### Report to Sydney Central City Planning Panel

<b>Panel Reference</b>	PPSSCC- 521
<b>DA Number</b>	<b>DA/72/2024</b> PAN-401664
<b>LGA</b>	City of Parramatta Council
<b>Proposed Development</b>	Demolition, earthworks, site remediation, tree removal and construction of a warehouse and distribution centre. The development is proposed in two phases, the existing hardstand surfaces to be utilised as storage premises in Phase 1 and warehousing and distribution premises will be constructed and operated under Phase 2. The application is Nominated Integrated Development pursuant to Water Management Act 2000 and Integrated Development pursuant to Roads Act 1993. The application will be determined by Sydney Central City Planning Panel.
<b>Street Address</b>	181 James Ruse Drive, Camellia
<b>Property Description</b>	Lots 1- 6 DP 2737, Lots 2 0 17 and 25 DP 6856 and Lots 1 – 4 DP 128720
<b>Applicant</b>	Abacus Camellia Investments Pty Limited
<b>Owner</b>	Abacus Camellia Investments Pty Limited

<b>Report Prepared By</b>	Denise Fernandez, Senior Development Assessment Officer
<b>Report Date</b>	8 January 2025

**Figure 5:** The Probably Maximum Flood Extent.

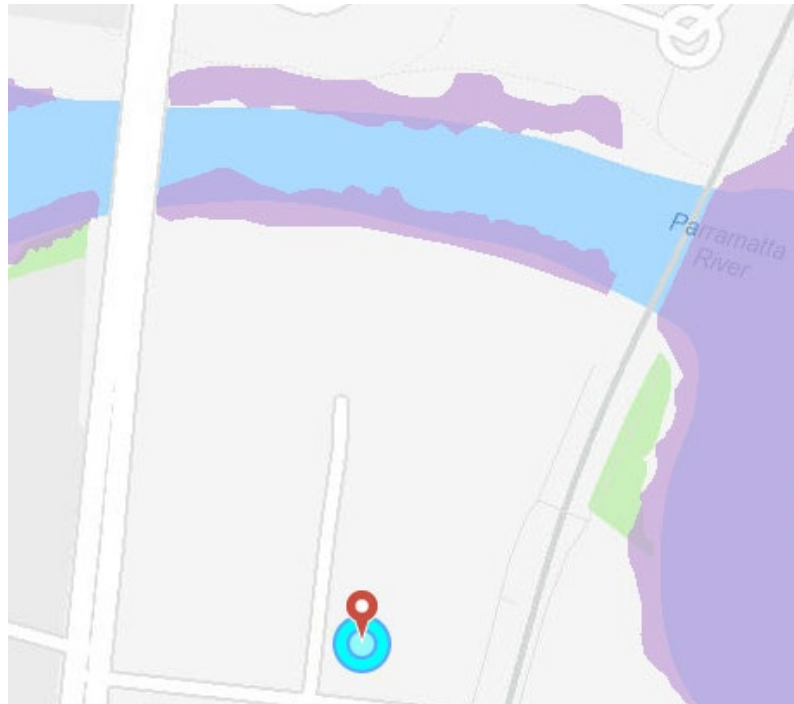
Catchment Engineer	<p>Not supported</p> <p>Council's Catchment Engineer raises concern that despite the development being designed to the 1% AEP flood level (with 500mm freeboard), evacuation from the premises must assess flooding up to the Probable Maximum Flood (<b>PMF</b>). During the <b>PMF</b>, the entire site will be inaccessible due to extremely hazardous (H5 to H6) floodwaters (Figure 5 below). The route along James Ruse Drive (north) towards the Western Sydney university (WSU) campus will also be inaccessible, and therefore horizontal evacuation impossible.</p> <p>A Flood Emergency Response Plan was submitted with the application. Council's Catchment Engineer has not endorsed this plan. Reliance on shelter-in-place in such an extreme-risk environment is not supported. The NSW Shelter-in-Place (<b>SIP</b>) Guidelines 2025 preclude <b>SIP</b> provisions in high-hazard flood areas (e.g., floodways and H5 or H6 hazard zones). Additionally, the amended climate change recommendations (August 2024) in ARR 2019 are expected to further worsen flooding conditions at this site.</p> <p>Significant filling or excavation of land below the Flood Planning Level (<b>FPL</b>) is generally not permitted as this would affect the floodway conveyance and / or flood storage. While a merit-based assessment has been requested on the application, the proposal does not meet the necessary criteria. Development proposals must demonstrate—</p>

<p>through detailed hydraulic modelling—that any proposed filling or excavation of land above the <b>FPL</b>, up to the <b>PMF</b>, will not adversely impact flood behaviour. However, in this case, most of the site is below the <b>FPL</b>, and the proposed excavation and filling would not be considered acceptable under a merit-based assessment.</p> <p>Additionally, excavation within contaminated land or allowing water to flow under a suspended slab poses further concerns. The DCP also designates filling as an unsuitable land use in high- and medium-risk flood areas (PDCP Table 5.1.1.2). This site falls within a medium flood risk zone at the 1% AEP flood level. Given these factors, the proposed works are not supported.</p>
Natural and Open Space Officer	<p>Not supported.</p> <p>Insufficient information has been received with regards to the submission of an adequate Vegetation Management Plan for the site. The documentation received pertains to a previous development application which has since been refused by Council (i.e. DA/465/2024).</p>

**Figure 8: Height Plane analysis.**

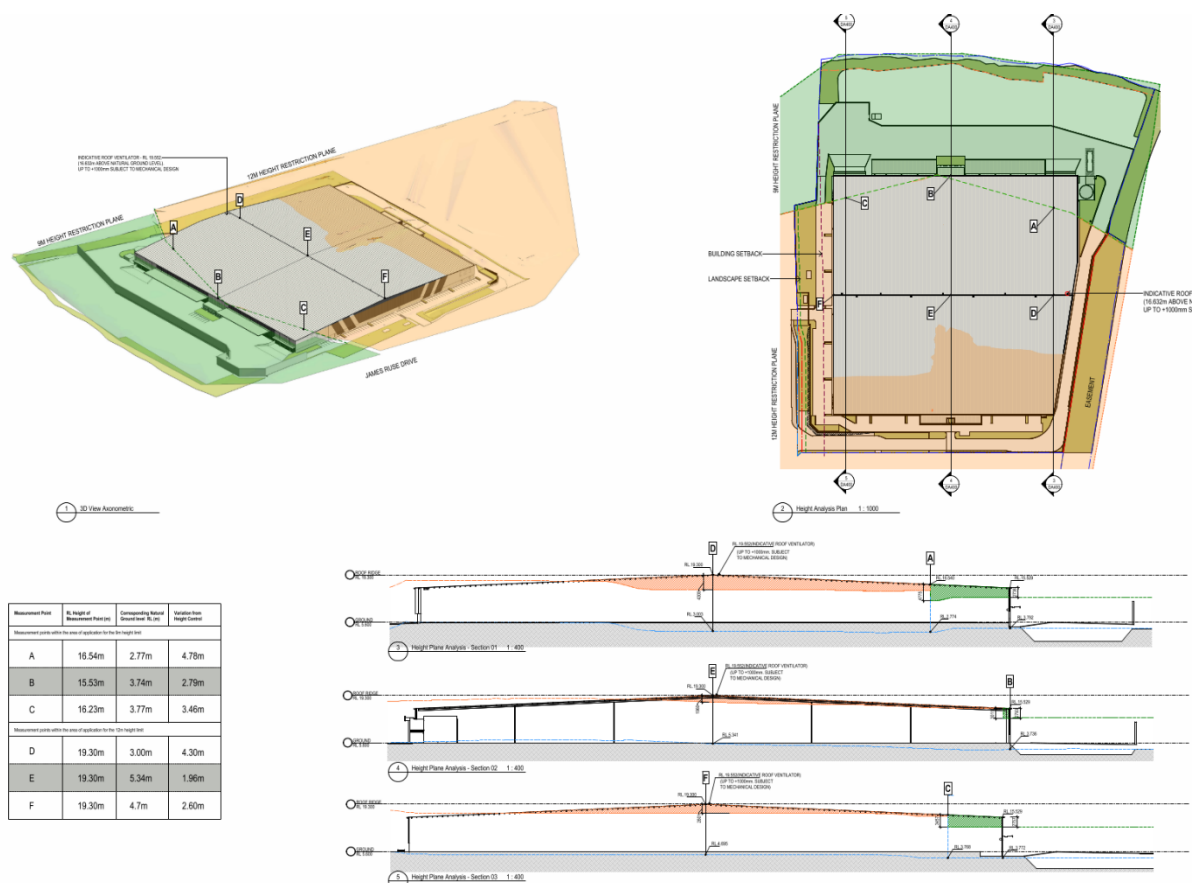
**Council Comment:** An assessment against the relevant case law established in the NSW Land and Environment Court has been undertaken below by the applicant. These cases establish tests that determine whether a variation under Clause 4.6 of an LEP is acceptable and whether compliance with the standard is unreasonable or unnecessary.

**Council Comment:** As previously demonstrated, some sites within proximity of the subject land have exceeded the applicable height control/s. With respect to scale, the building has been designed sympathetically to the surrounding area accounting for the environmental constraints of the site by providing suitable setbacks to the river and light rail corridors.
